Request for Proposal, 18MCO538

In response refer to RFP No. 18MCO538 Addendum 1 (one) with Questions and Answers

October 19, 2018

SPECIFICATION:

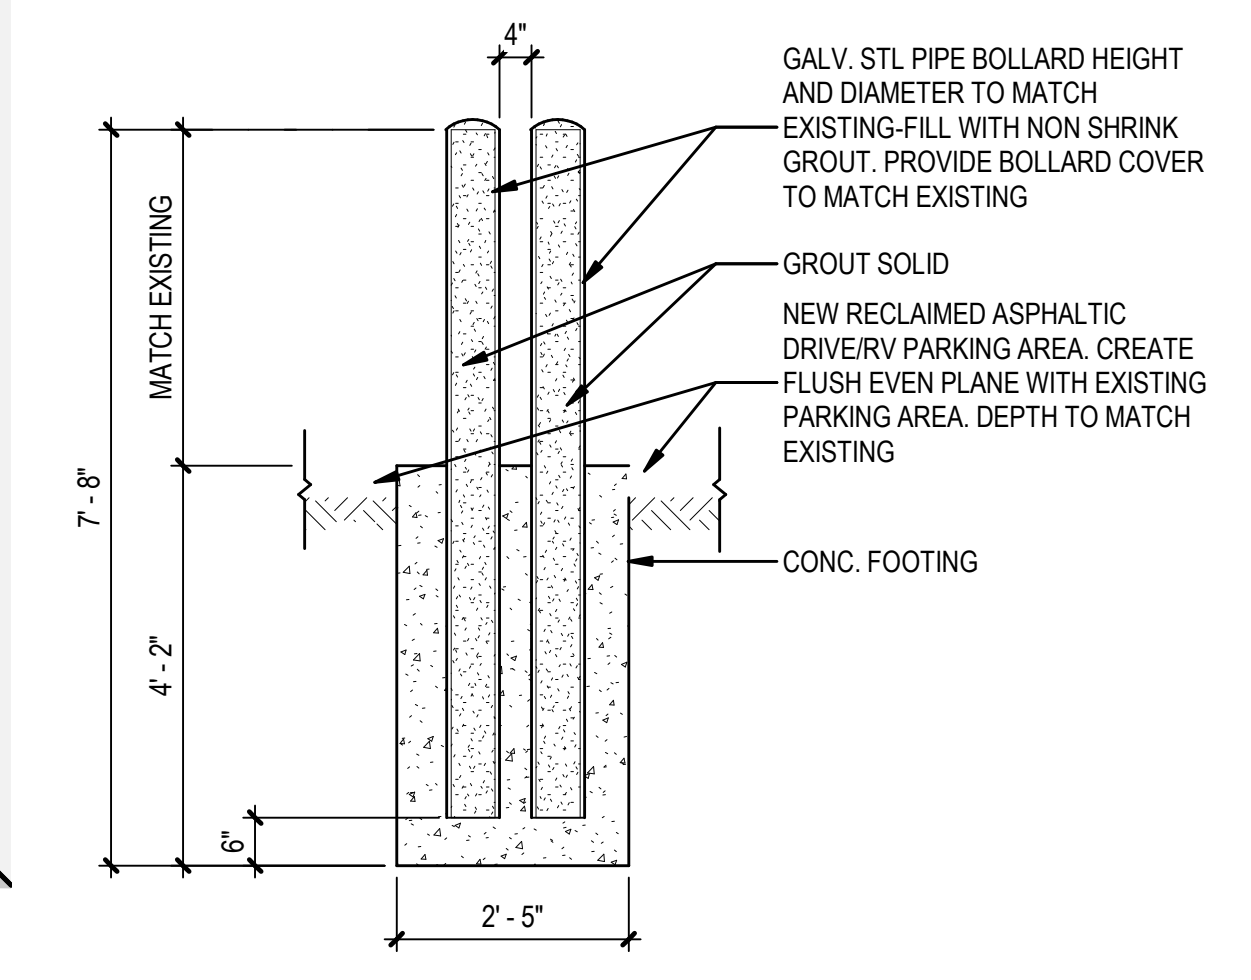
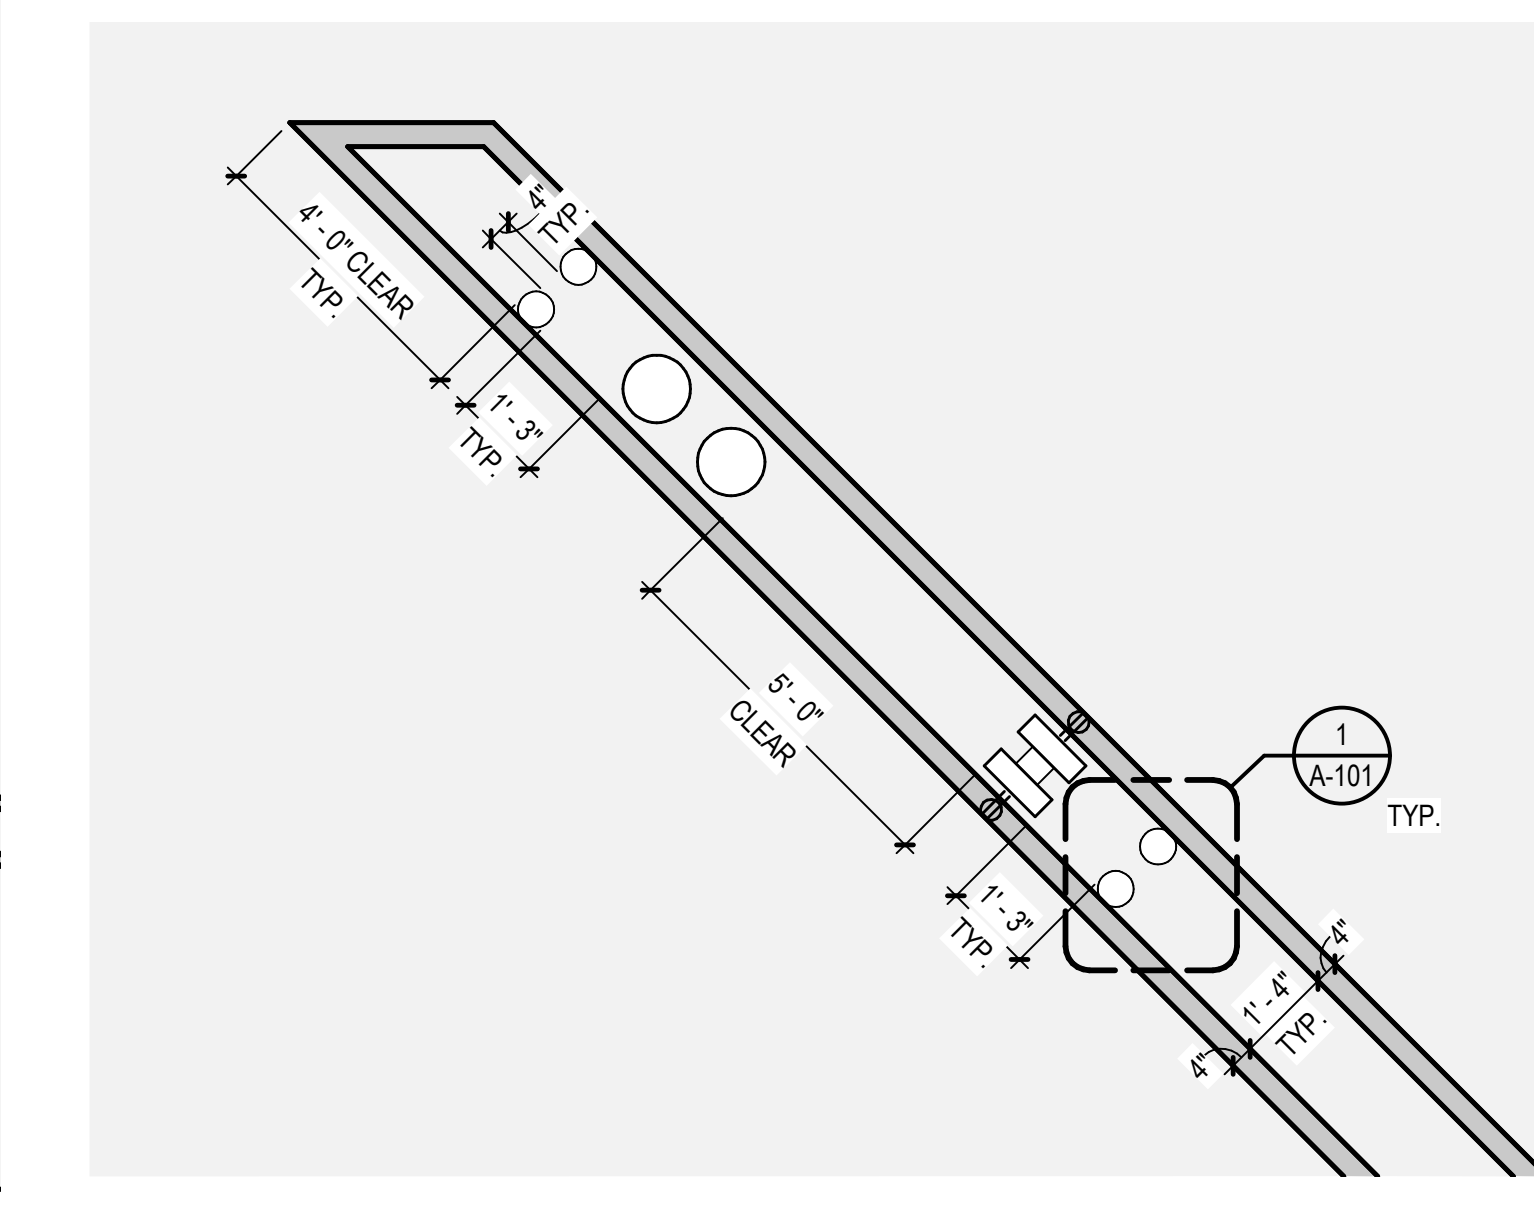
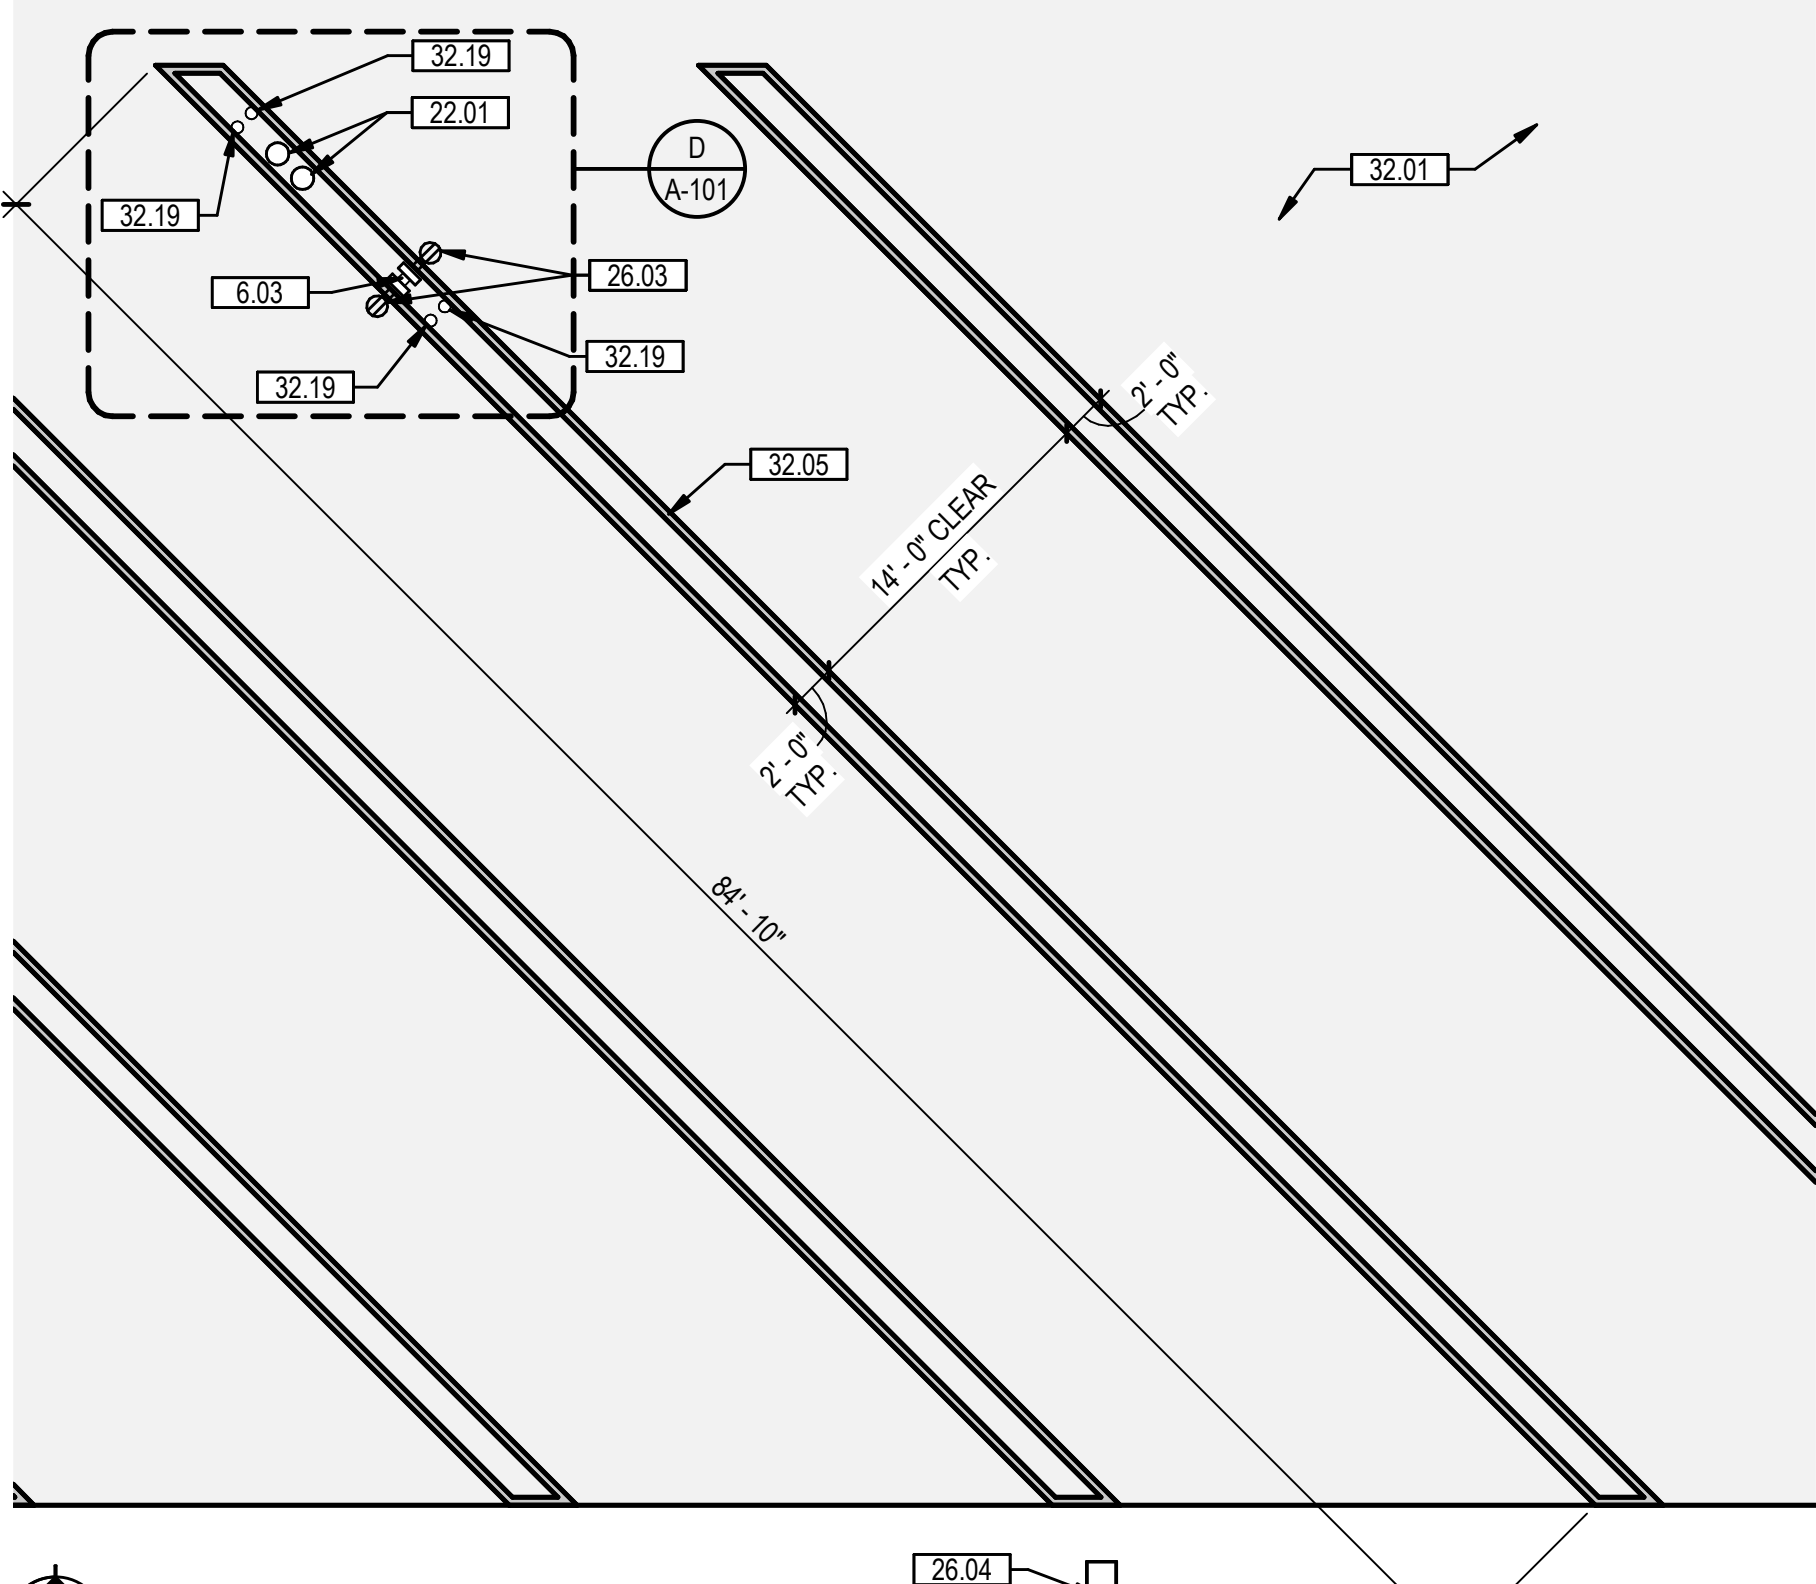
Vendor will be responsible for providing all supplies, equipment and labor to re-pave these lots with an asphalt paving as smooth as Arena Trail (the road leading into the Horseshoe Complex from S. Garfield St. This project is to include ~~removal of current pavement and~~ hauling away all debris. Vendor is responsible for all permitting and for meeting City of Midland codes regarding paving of parking lots. Vendor will also be responsible for re-stripping the parking spaces.
